**14 CFR Parts 25 and 121
Improved Flammability Standards for
Materials Used in the Interiors of
Transport Category Airplane Cabins; Final
Rule**

[Docket No. 24594; Amendment Nos. 25-66 and 121-198]

Improved Flammability Standards for Materials Used in the Interiors of Transport Category Airplane Cabins**AGENCY:** Federal Aviation Administration (FAA), DOT.**ACTION:** Final rule; Findings concerning additional comments.

Figure 2A. "Globar" Radiant Panel

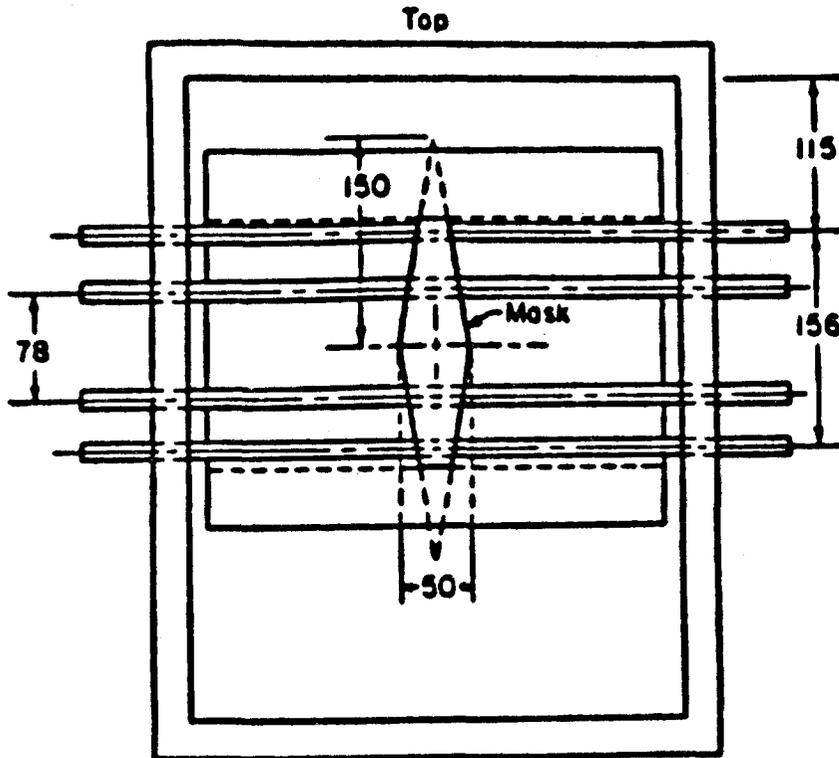
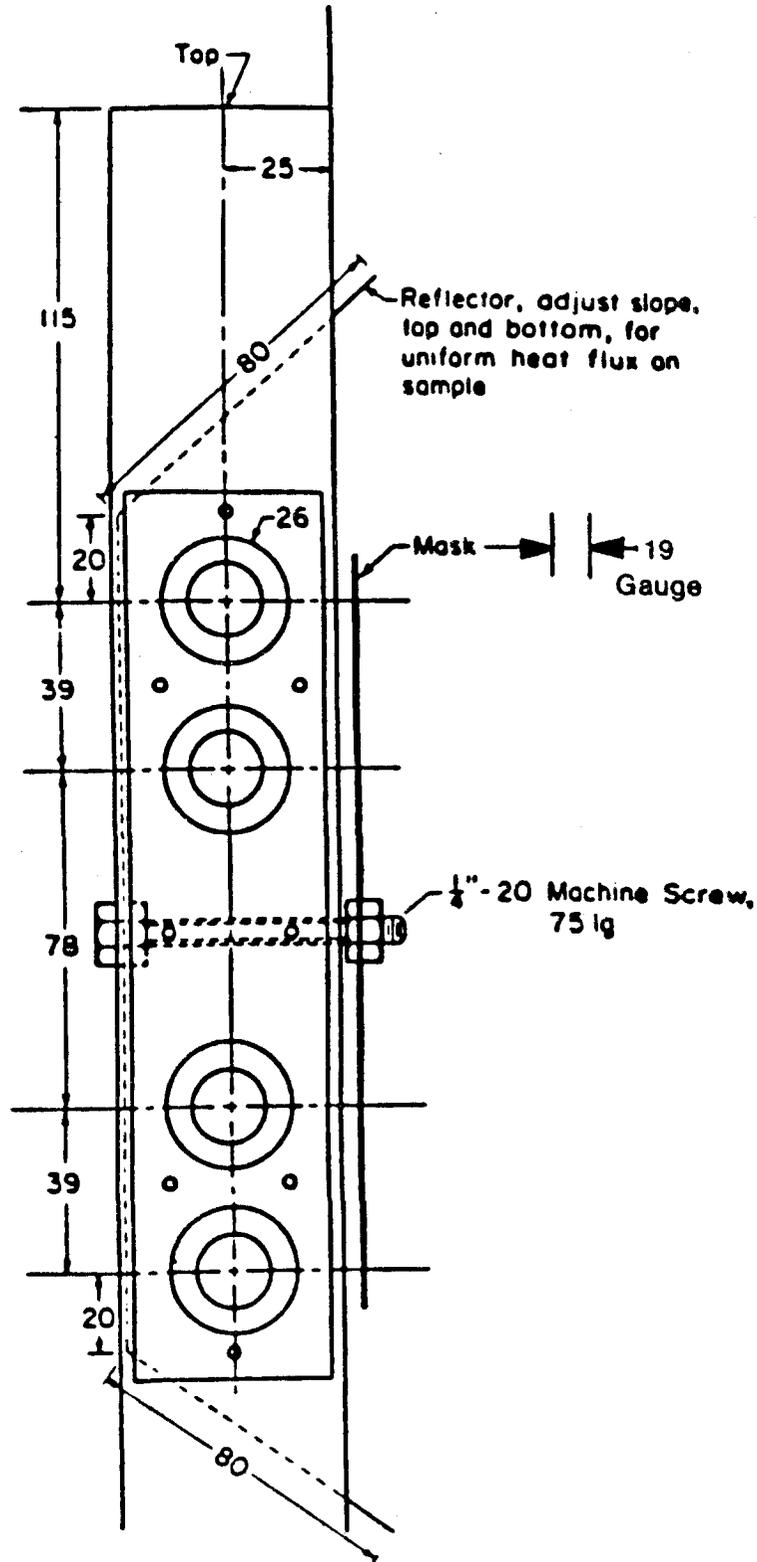
(3) *Radiation Source.* A radiant heat source for generating a flux up to 100 kW/m², using four silicon carbide elements, Type LL, 20 inches (50.8 cm) long by 3/8 inch (1.54 cm) O.D., nominal resistance 1.4 ohms, is shown in Figures 2A and 2B. The silicon carbide elements are mounted in the stainless steel panel box by inserting them through 15.9-mm holes in 0.8 mm thick ceramic fiber board. Location of the holes in the pads and stainless steel cover plates are shown in Figure 2B. The diamond shaped mask of 24-gauge stainless steel is added to provide uniform heat flux over the area occupied by the 150- by 150-mm vertical sample.

Figure 3.

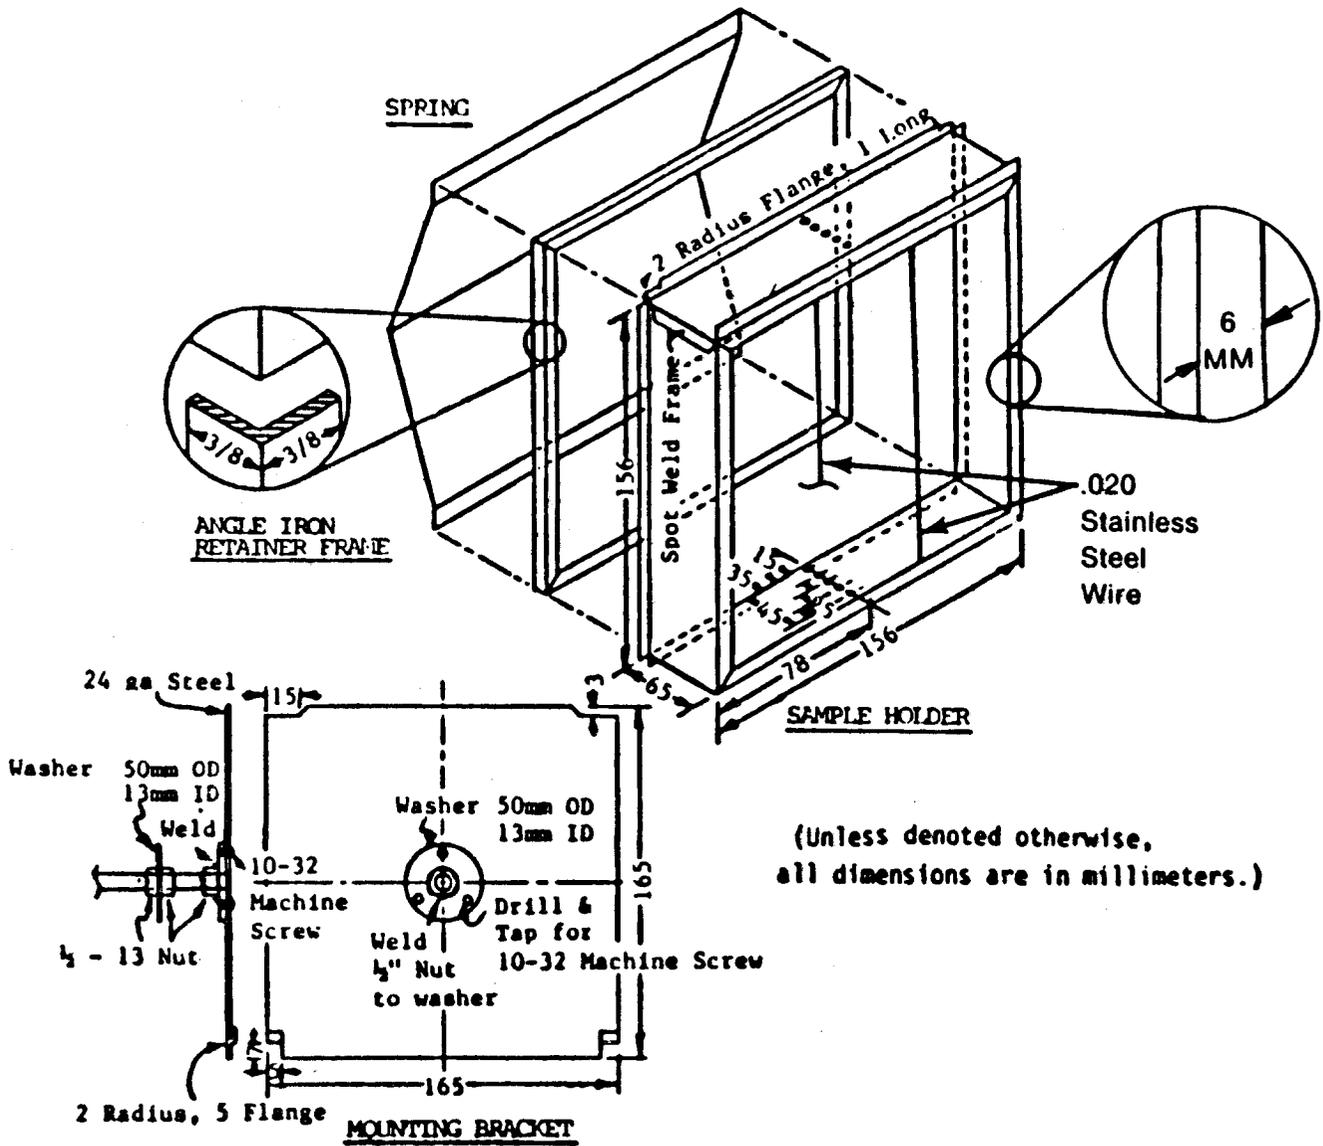
(6) *Specimen Holders.* The 150-mm x 150-mm specimen is tested in a vertical orientation. The holder (Figure 3) is provided with a specimen holder frame, which touches the specimen (which is wrapped with aluminum foil as required by paragraph (d)(3) of this Part) along only the 6-mm perimeter, and a "V" shaped spring to hold the assembly together. A detachable 12-mm x 12-mm x 150-mm drip pan and two .020-inch stainless steel wires (as shown in Figure 3) should be used for testing of materials prone to melting and dripping. The positioning of the spring and frame may be changed to accommodate different specimen thicknesses by inserting the retaining rod in different holes on the specimen holder.

The specimen holder clips onto the mounted bracket (Figure 3). The mounting bracket is attached to the injection rod by three screws which pass through a wide area washer welded onto a 1/2-inch nut. The end of the injection rod is threaded to screw into the nut and a .020 inch thick wide area washer is held between two 1/2-inch nuts which are adjusted to tightly cover the hole in the radiation doors through which the injection rod or calibration calorimeter pass.

Figure 4.

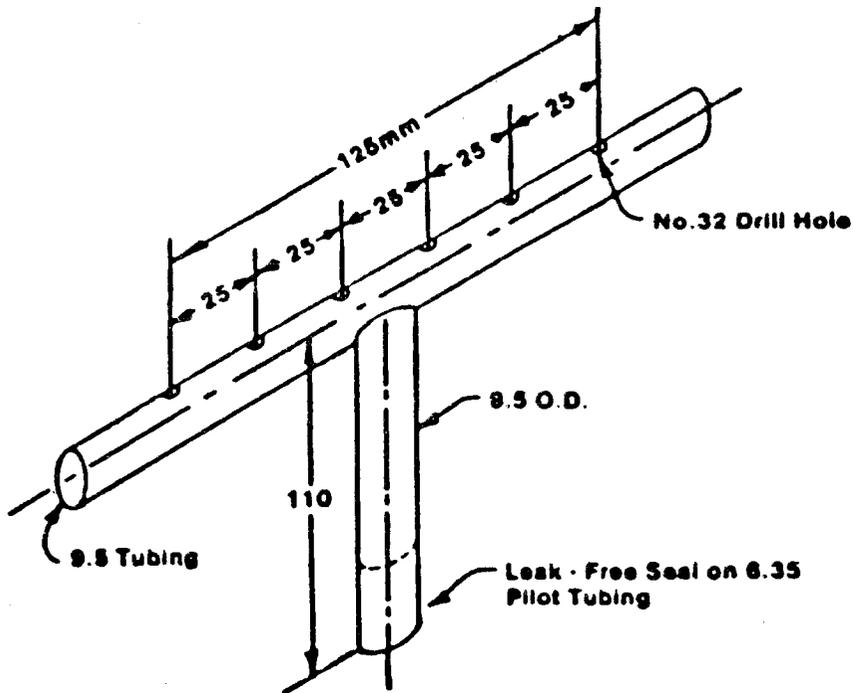
(1) *Heat Release Rate.* A burner as shown in Figure 4 must be placed over the end of the lower pilot flame tubing using a gas tight connection. The flow of gas to the pilot flame must be at least 99 percent methane and must be accurately metered. Prior to usage, the wet test meter is properly leveled and filled with distilled water to the tip of the internal pointer while no gas is flowing. Ambient temperature and pressure of the water are based on the internal wet test meter temperature. A baseline flow rate of approximately 1 liter/min is set and increased to higher preset flows of 4, 6, 8, 6, and 4 liters/min. The rate is determined by using a stopwatch to time a complete revolution of the wet test meter for both the baseline and higher flow, with the flow returned to baseline before changing to the next higher flow. The thermopile baseline voltage is measured. The gas flow to the burner must be increased to the higher preset flow and allowed to burn for 2.0 minutes, and the thermopile voltage must be measured.
